City of Falcon Heights Planning Commission

1. PUD Amendment – Fairway Commons

FAIRWAY COMMONS

1644 Larpenteur Ave W, Falcon Heights, 55113

GRADING PLAN

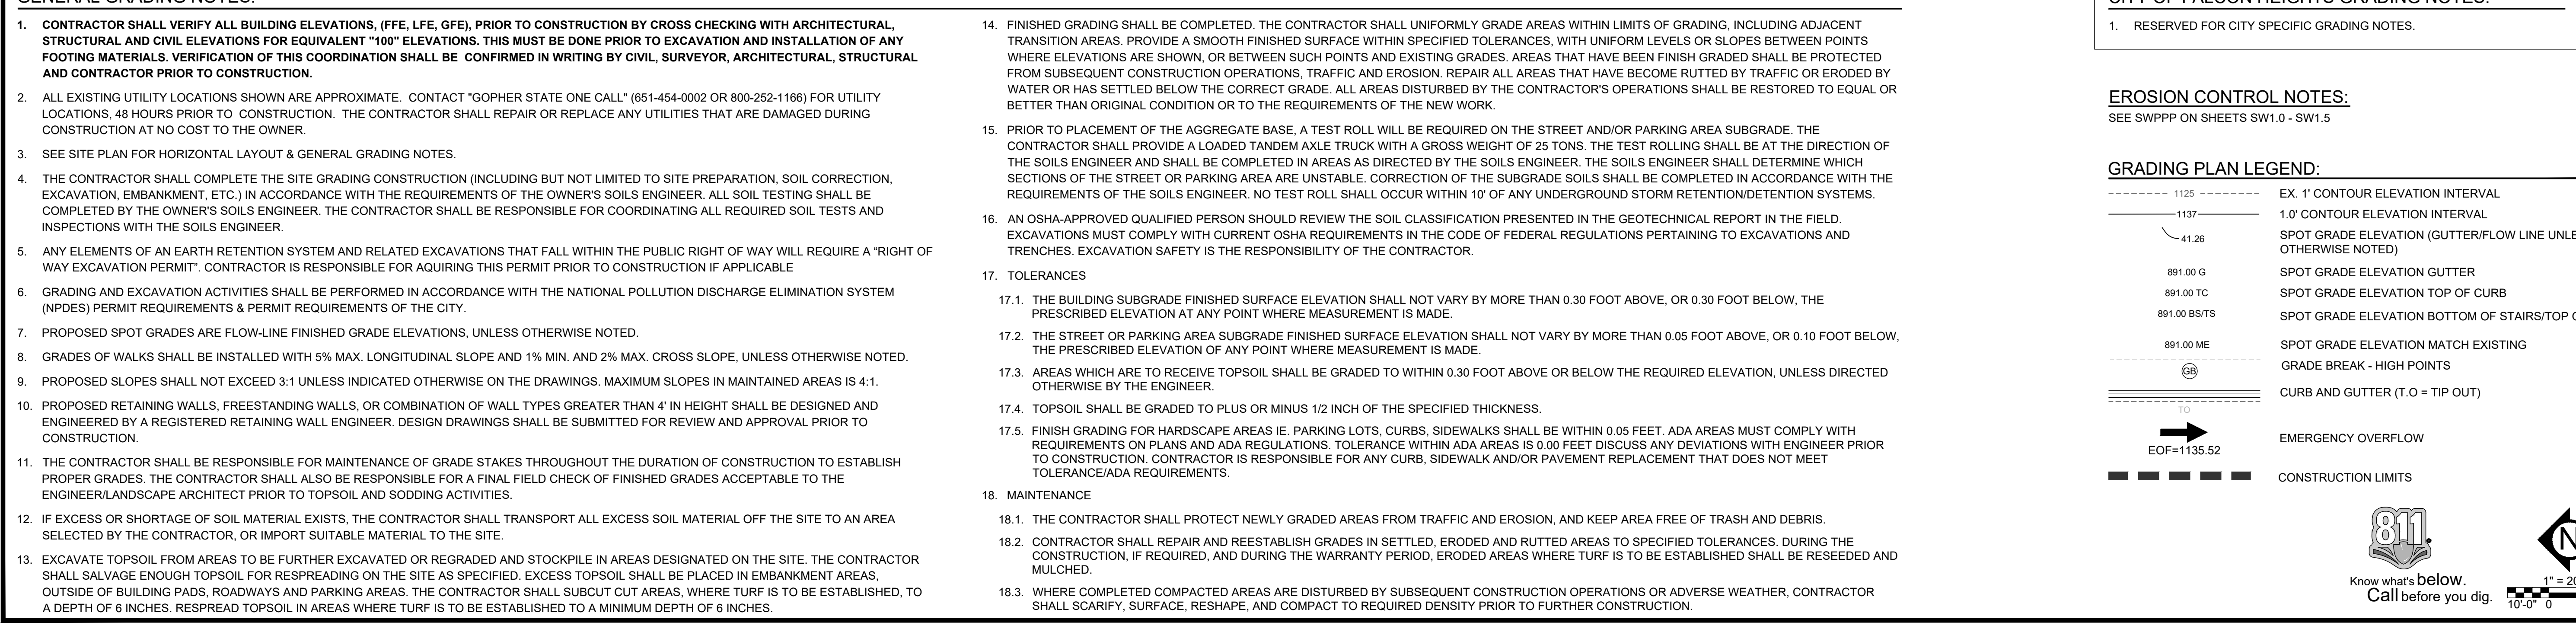
- C3.0 – Add a note to the grading plan that no construction traffic is allowed over the BMP(s) during any phase of the project
- C3.0 – Add a note to the grading plan that no wheeled machines shall be used to excavate BMP(s), and/or during the backfilling.

- C3.0 – Add a note to the Grading Plan to notify City of Roseville Engineering Dept. at 651-792-7004, at least 24 hours prior to the construction of stormwater BMPs.

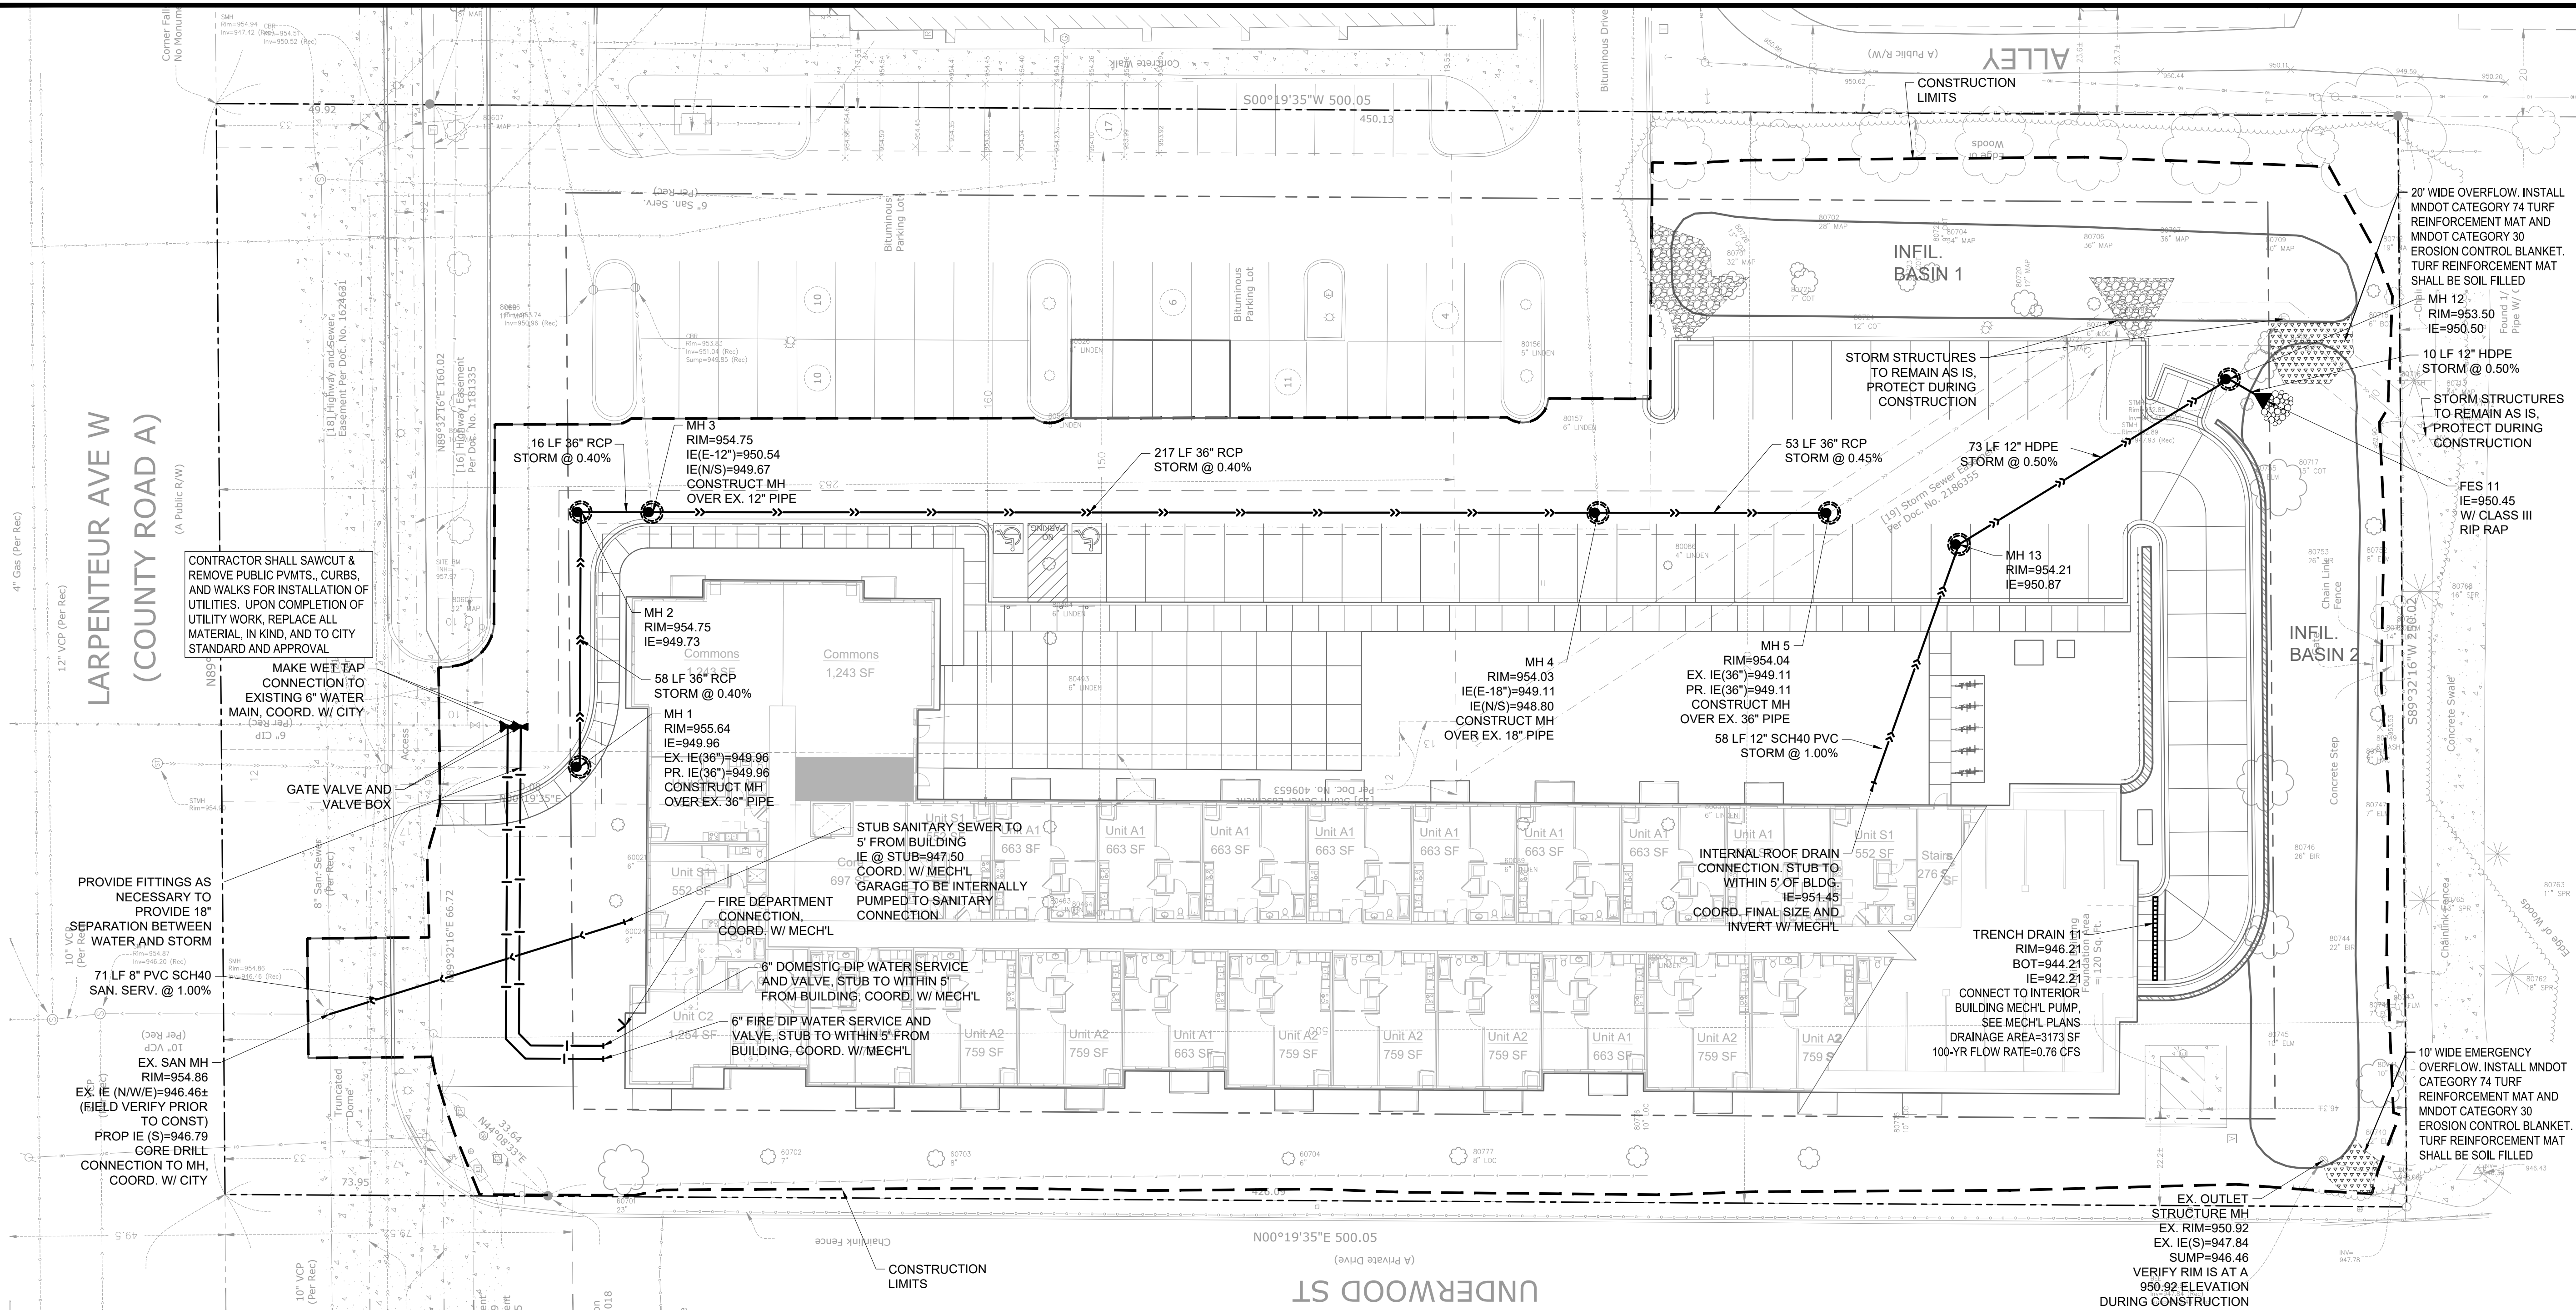
- C4.0 - Proposed pipe alignment should be moved north so any future work by the City can be completed without having to remove curb and sidewalk.
- C4.0 - Proposed pipe alignment will require a new easement be recorded in favor of the City over the pipe sufficient to achieve a 1:1 slope from edge of pipe (minimum 20' wide). Any existing public easements not encumbering a public stormwater pipe shall be vacated.
